PRODUCT CHANGE NOTIFICATION (PCN)

AMJE0909-0050-YEB-24
MODULAR CABLE

CHANGE NOTIFICATION: PCN 20220509_AMJE0909-0050-YEB-24

DESCRIPTION OF CHANGES:
CHANGE OF DATA SHEET
CHANGE OF DATA SHEET
New Draw.-No. ASS_7945_CArev02

AMJE0909-0050-YEB-24 OLD VERSION

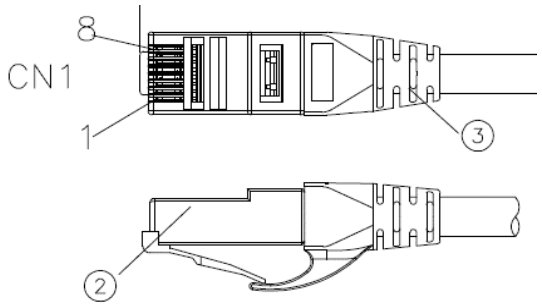
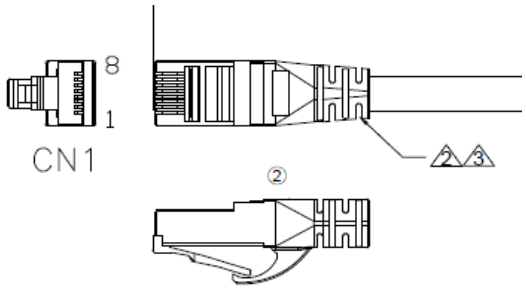
③	Molding	PVC 45P Color: see order code	NA	KG
②	CONNECTOR	RJ45 8P8C two fork Short type 3u" gold plated	2	PCS
①	CABLE	CAT6 UTP (24AWG*1PR)*4+PVC OD=5.8±0.3MM Color: see order code	NA	MM
NO:	NAME	DESCRIPTION	Q'TY	UNIT

3	Molding	PVC 65P Color: see order code ②	NA	KG
2	CONNECTOR	RJ45 8P8C PLUG 3u" gold plated ②	2	PCS
1	CABLE	CAT6 U/UTP (24AWG*1PR)*4+Cross+PVC Jacket OD=5.8± 0.3MM Color: see order code ②	NA	MM
NO:	NAME	DESCRIPTION	Q'TY	UNIT

Drawing-No.
ASS 7945 CA

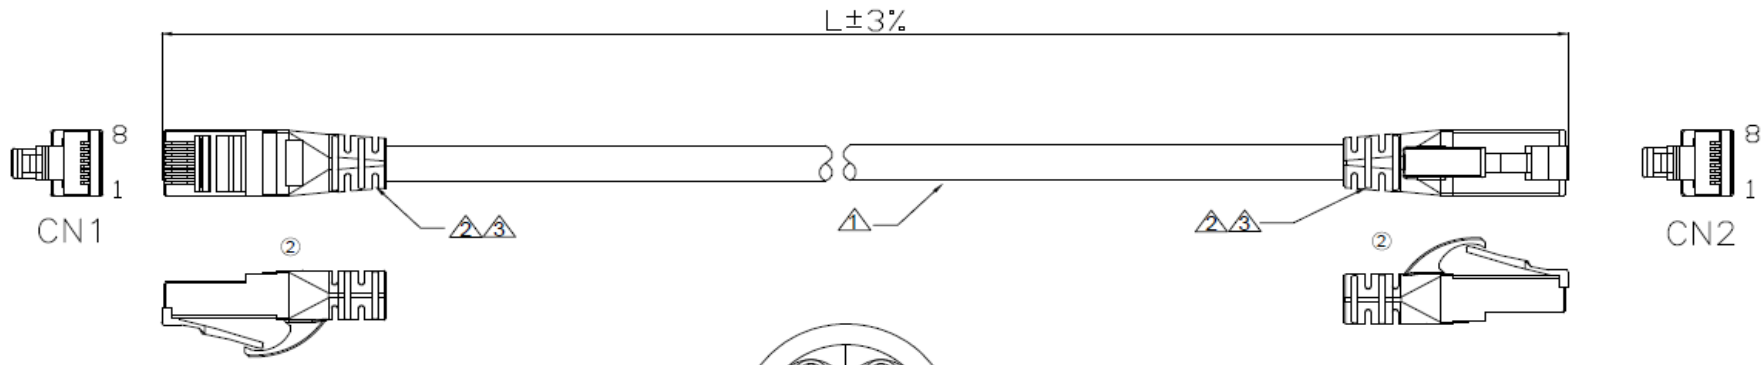
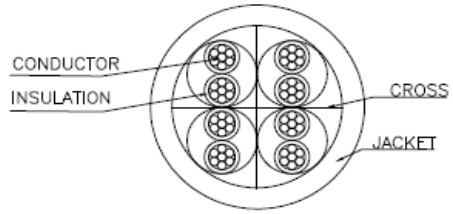
Id.	Modification	Date	Name
②	Change the plant	09.05.2022	Luca
①	Update the WSW order code	02.06.2017	Amy
⓪	Drawn	30.03.2017	Amy

NO:	NAME	DESCRIPTION	Q'TY	UNIT
3	Molding	PVC 65P Color: see order code ②	NA	KG
2	CONNECTOR	RJ45 8P8C PLUG 3u" gold plated ②	2	PCS
1	CABLE	CAT6 U/UTP (24AWG*1PR)*4+Cross+PVC Jacket OD=5.8± 0.3MM Color: see order code ②	NA	MM
